**CITY OF WEST DES MOINES
STAFF REPORT COMMUNICATION**

ITEM: Woodland Estates Plat 1, Generally NE corner of S. Kingswood Court and Stagecoach Drive – Approve a Preliminary Plat to create 21 lots for Single Family Residential development – Silo 9 LLC – PP-005161-2021

PRELIMINARY PLAT FOR: WOODLAND ESTATES PLAT 1

TYPICAL SECTION - 61' B-B PCC ROADWAY - STAGECOACH DRIVE

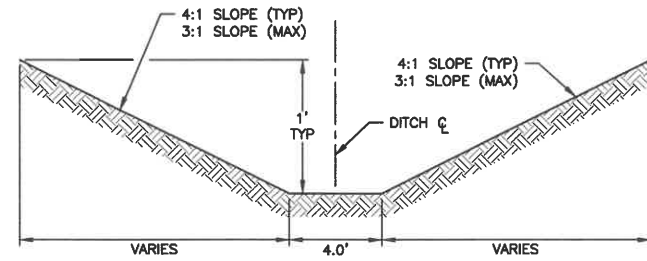
- *Traffic Impact Study Findings:* The study identified that the site is expected to generate less traffic than previously assumed. The study indicates that S 95th Street should be a 2-lane roadway widening to 3-lanes for left turns at Stagecoach Dr (and ultimately at Mills

Civic Parkway and possible Cascade Avenue). An additional lane of Stagecoach Drive adjacent to the development will be needed in the future.

1. The Developer acknowledging the responsibility for the future construction of an additional lane of Stagecoach Drive. The developer agreeing that their execution of the associated Development Agreement shall be provided to the City prior to City Council consideration of the associated final plat.

WOODLAND ESTATES PLAT 1
GRADING PLAN
 WEST DES MOINES, IOWA
 2011.635

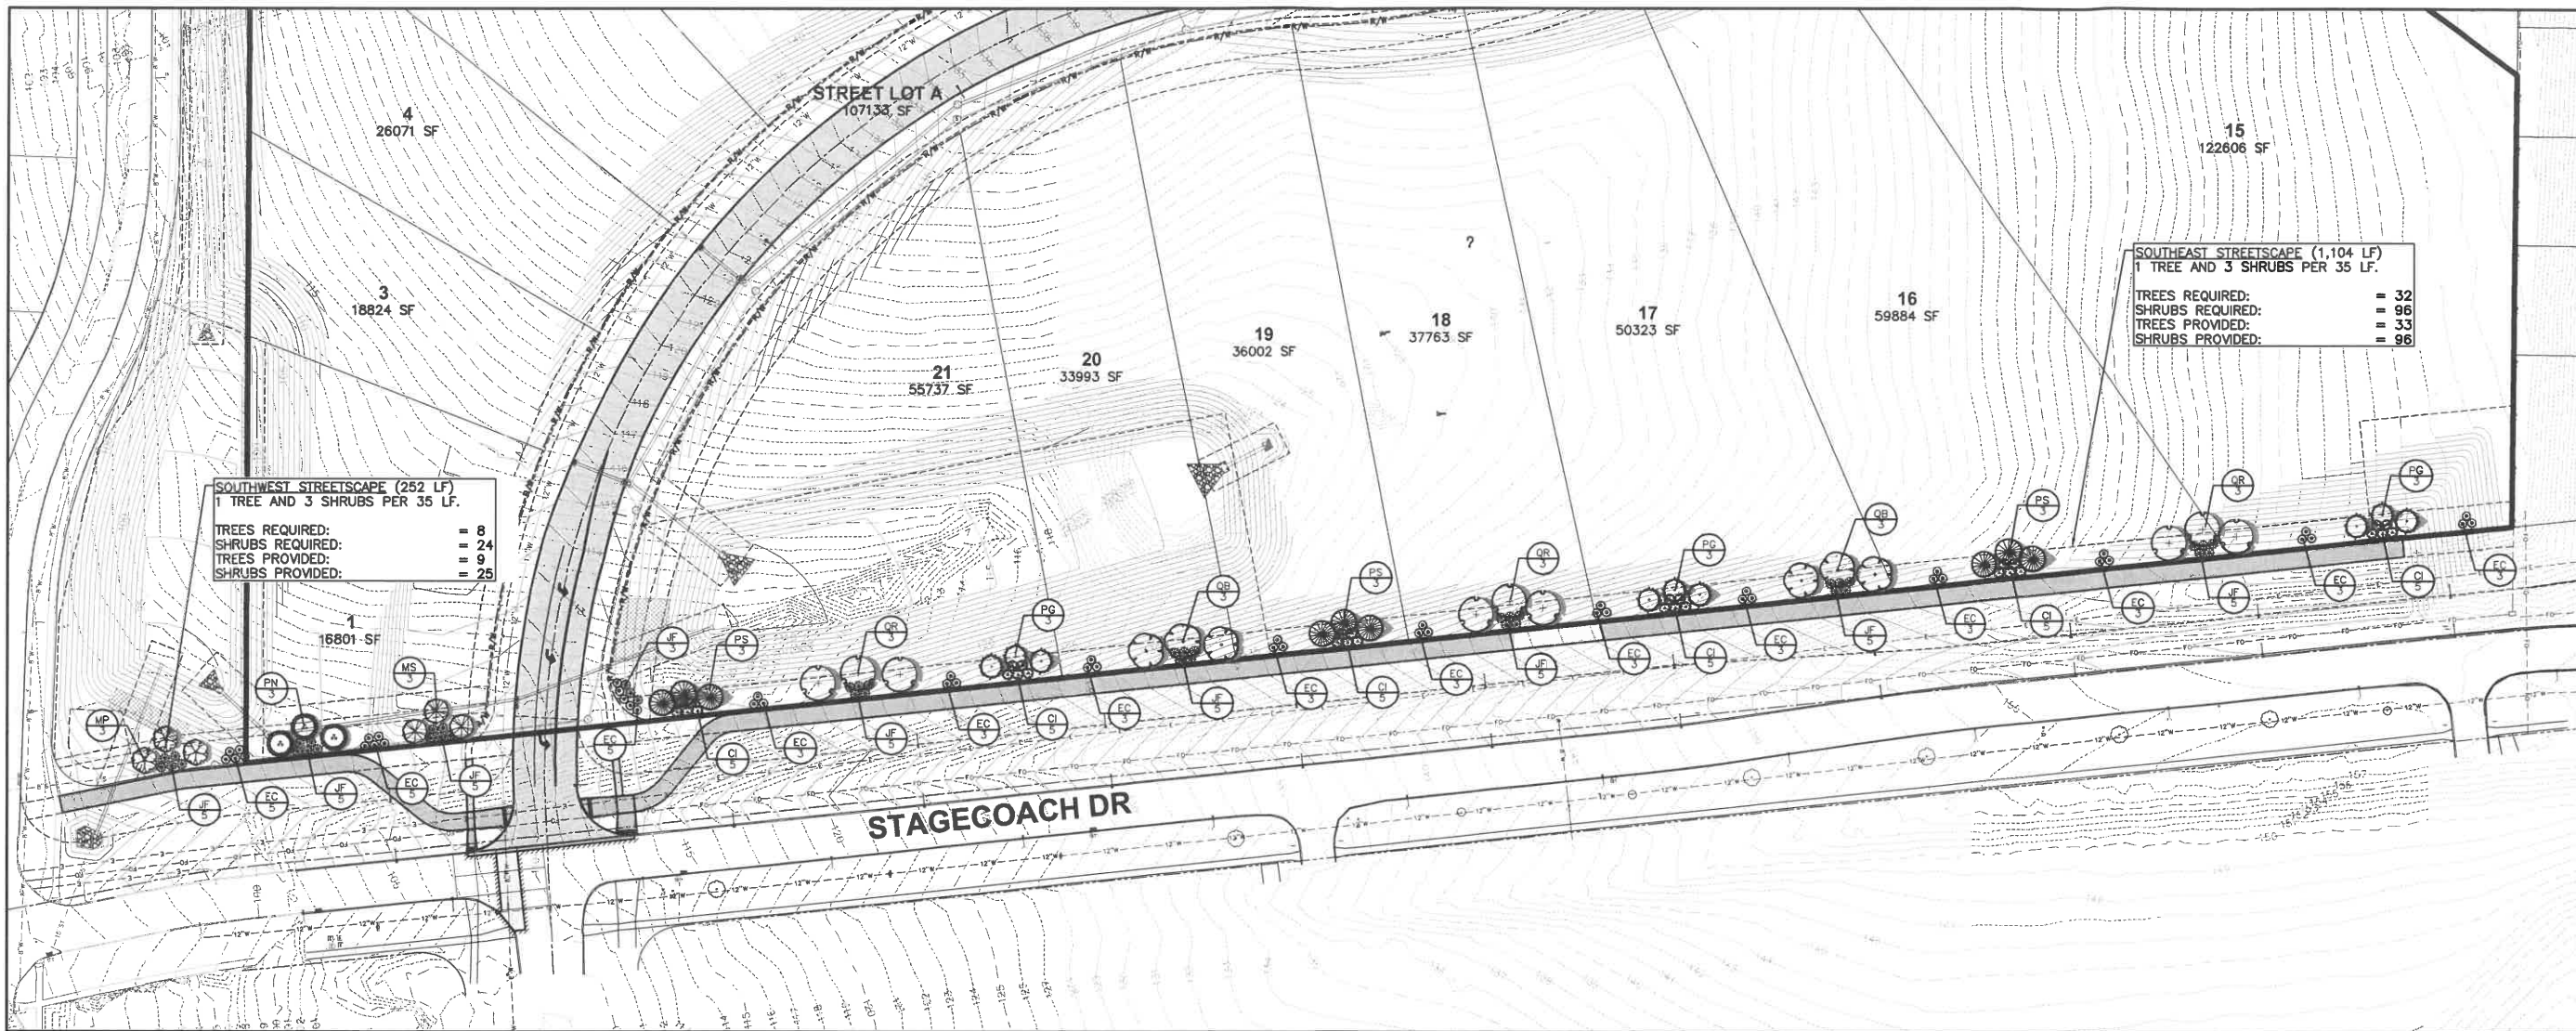
- Lots adjacent to Stagecoach Drive: With the exception of trees removed to accommodate storm water detention facility improvements and road grading, these lots are heavily wooded and extremely deep. Therefore in lieu of a traditional buffer, the applicant has requested, and staff supports, an alternative plan that continues the streetscape plantings implemented with Woodland Hills of West Des Moines Plat 1 immediately to the east (case #PP-2013-004 & FP-2013-018). That streetscape is 15' in width and required the planting of 1 overstory or evergreen tree or 2 understory trees and 5 shrubs for every 25 linear feet of lot adjacent to Stagecoach Drive. This 15' streetscape would be placed on the south lot line of Lot 1 as corner lots are required to continue a buffer, as well as on Lots 15-21.

- Lot 10: In anticipation of a future road extending off S. Kingwood Court from the Majestic Oaks development, Lot 10 will someday be a double frontage lot. This lot is the only lot in this area with this situation. While the lot is wooded the vegetation is not immediately adjacent to the road. As there is no precedent of a Streetscape in this area, this lot is being required to provide a buffer per width and vegetation requirements consistent with city code along its rear lot line. The timing of construction of the road along the rear of the lot is unknown. Therefore, to prevent damage to the buffer during road construction, the installation of the buffer is being deferred until after the area is graded and any construction that could affect the plantings is complete. Staff would recommend that the developer provide surety for the future implementation of the plants, labor to install, mulching and seeding of the buffer area prior to the associated Woodland Estates Plat 1 final plat proceeding to the City Council for approval.

3. The City Council granting allowance of the placement of Public Utility Easements (PUEs) in the front yard of all lots.
4. The City Council accepting the continuation of the Stagecoach Drive Streetscape Planting Plan in lieu of a 30' buffer along the rear (south) lot line of lots 15-21 and the side (south) lot line of lot 1.

5. The City Council granting a deferral of the installation of the buffer along the rear lot line of Lot 10 until such time that the adjacent future street is graded and any construction that may affect the survivability of the buffer plantings is complete.
